SUBMITTAL COVERSHEET Nanuet UFSD –Phase 3 Projects

School Name: Nanuet Union Free School District Phase 3 Bond Projects @ Barr Middle School & Nanuet High School

shop dwg mechanical piping high school basment part plan area 1

SAGE LOG NO. M-33

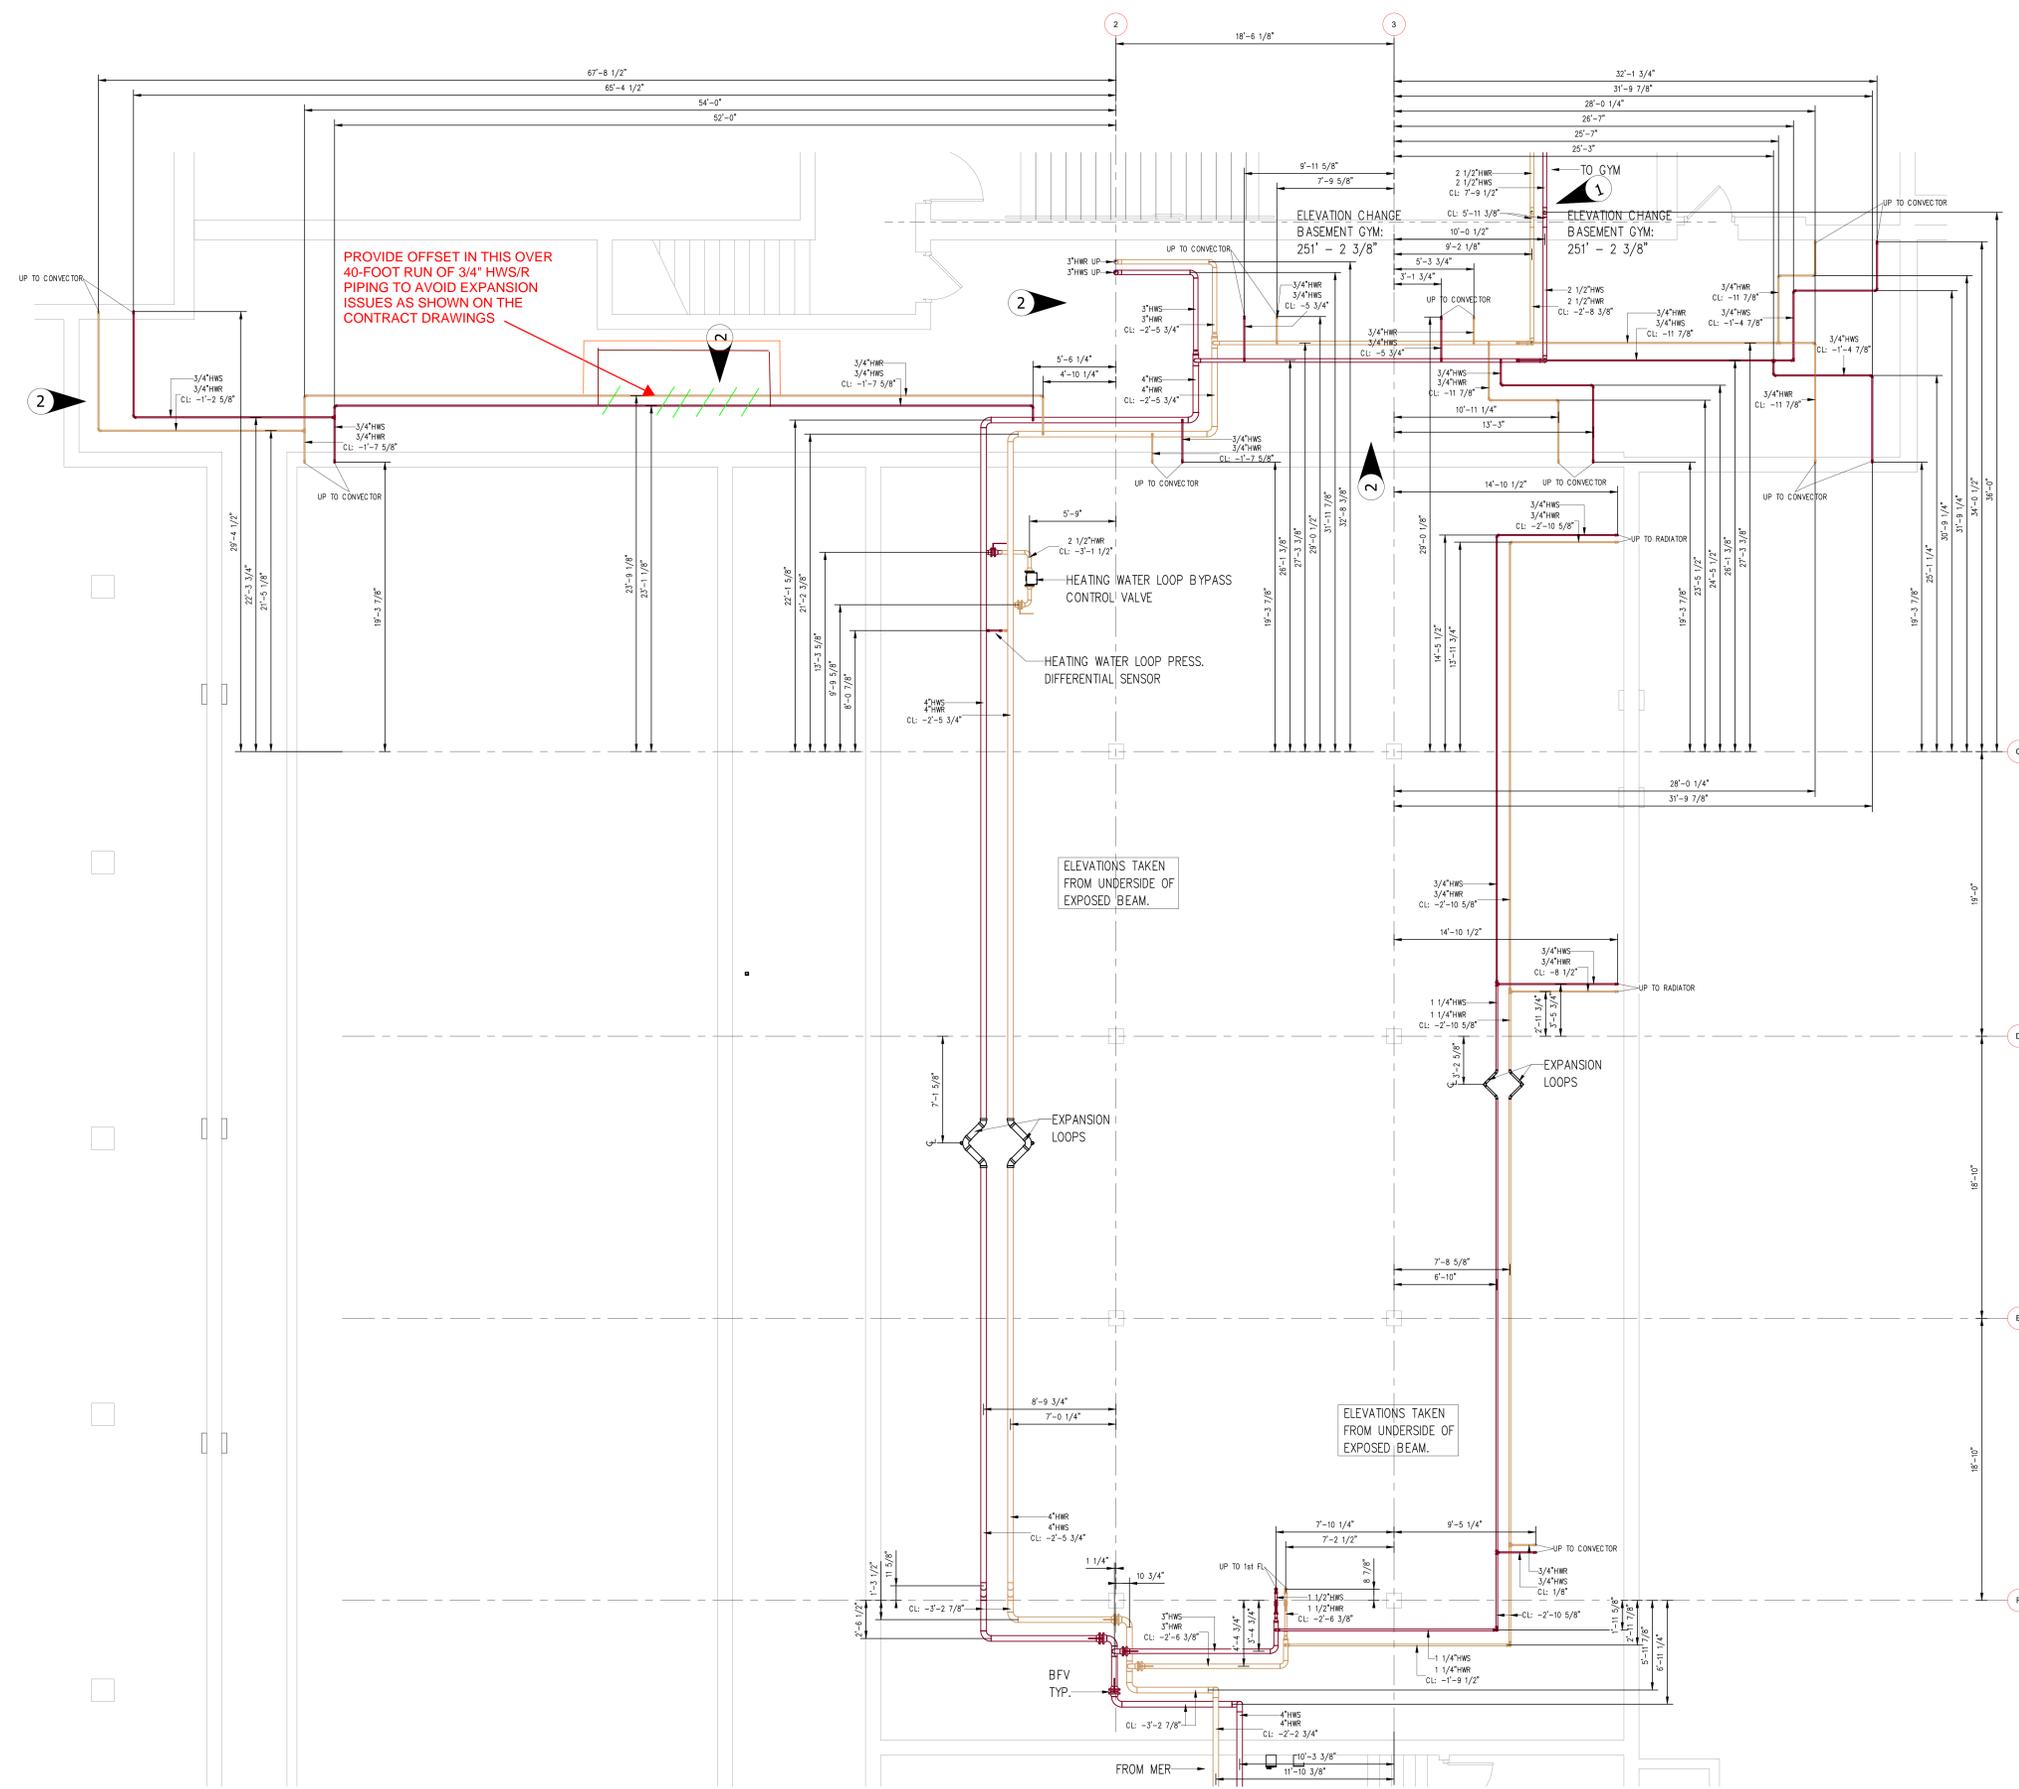
PROVIDE OFFSET IN THIS OVER 40-FOOT RUN OF 3/4\"/>
